# MAIN STREET TOWNHOUSES

83 MAIN ST, NETCONG NJ 07857

**TITLE SHEET,  
ZONING CHART &  
INFORMATION,  
MAPS, DRAWING  
LIST**

1 CARPET TO LVT TRANSITION

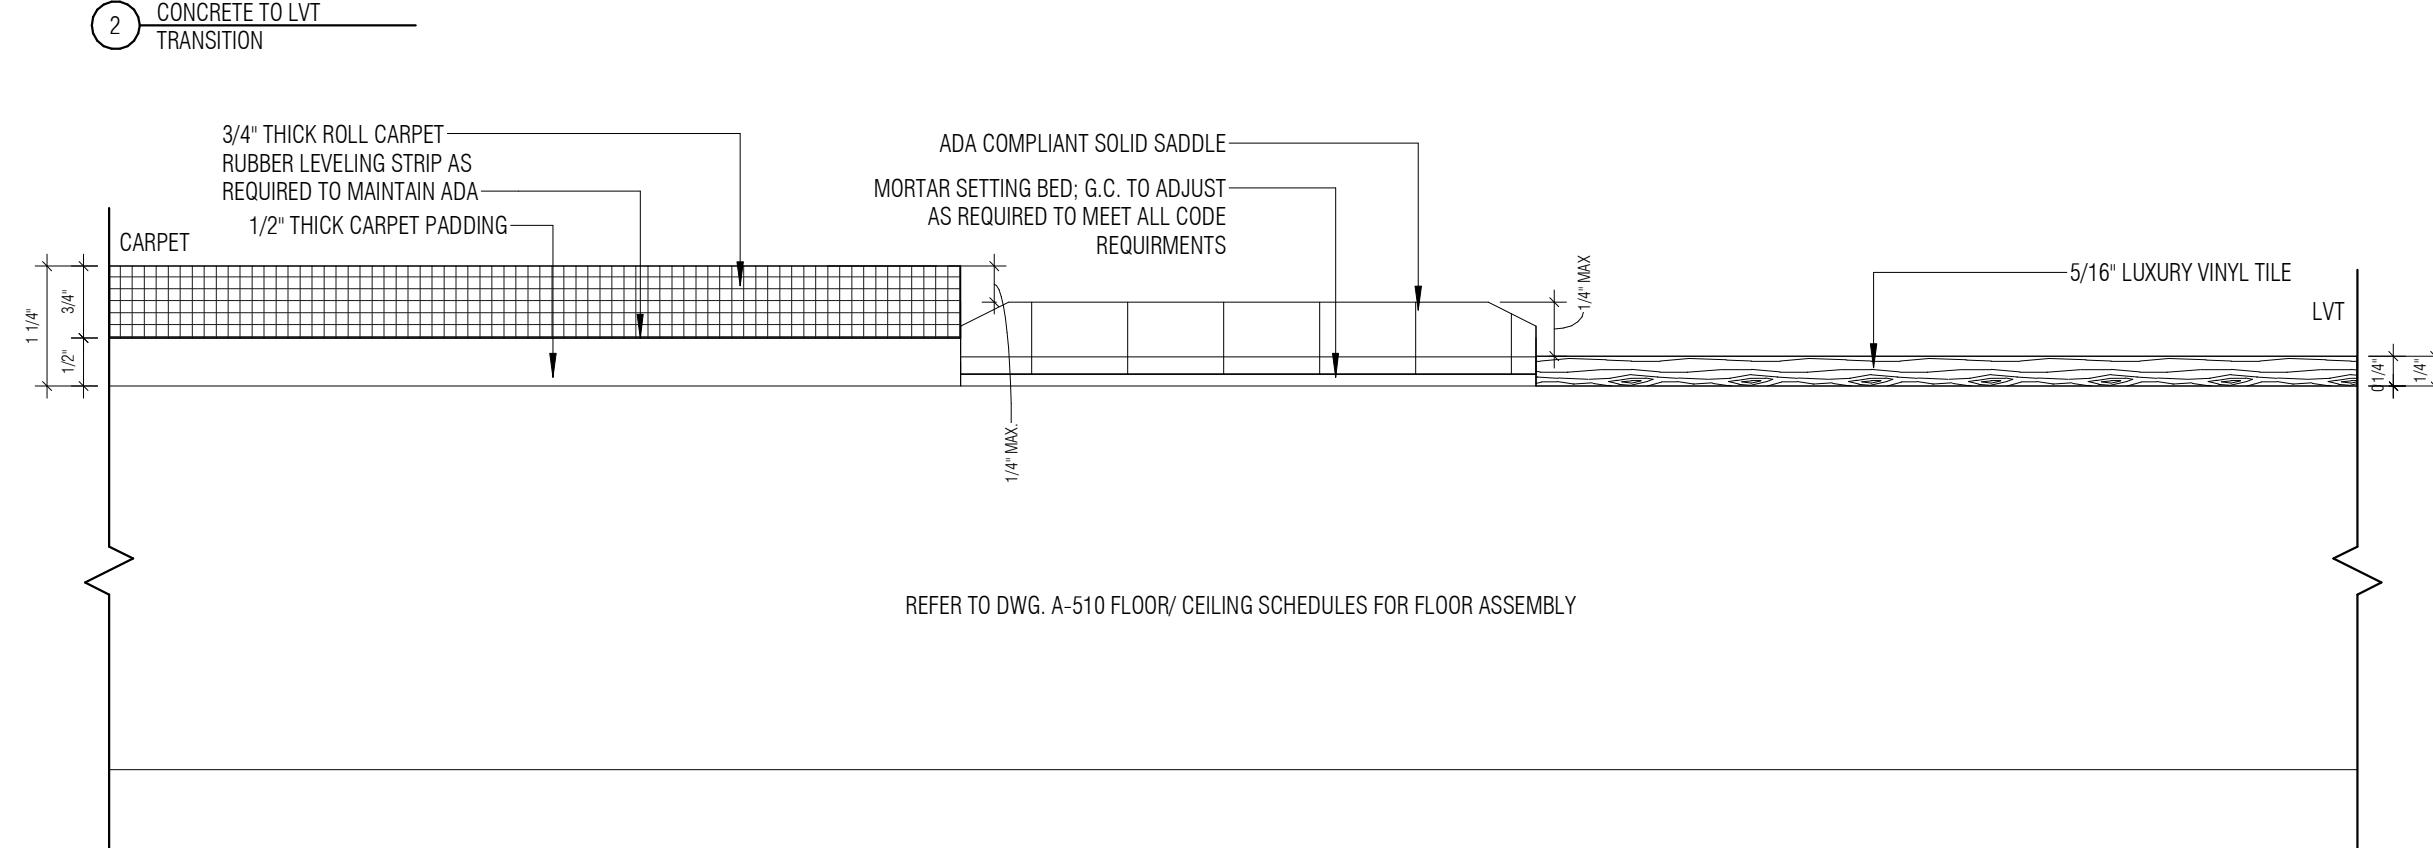
WHAT TYPE OF FLOOR FINISH ARE WE PROPOSING? I DON'T THINK WE NEED ALL OF THESE. PLEASE ADVISE.
